## 2011 Change Proposals - New Allowances (4 Items) Posted by joepaluch - 27 Oct 2010 06:04

These are **PROPOSED** Changes only based on driver and director suggestions. Please comment below. These are prposed NEW allowances to the 944 spec rule set.

2011-4.) Lexan rear Qtr windows

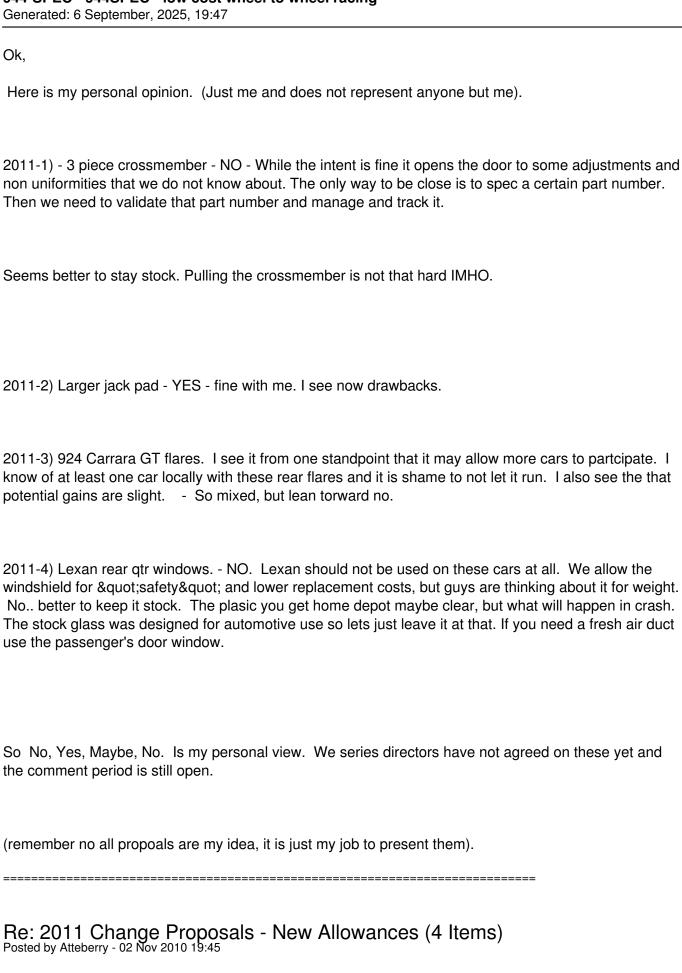
Proposal: Allow rear replacement of glass gtr windows with lexan and to allow air ducting to be installed in these lexan windows. No changes to rear hatch.

Justification: Makes it a nice clean way to provide fresh air ducting.
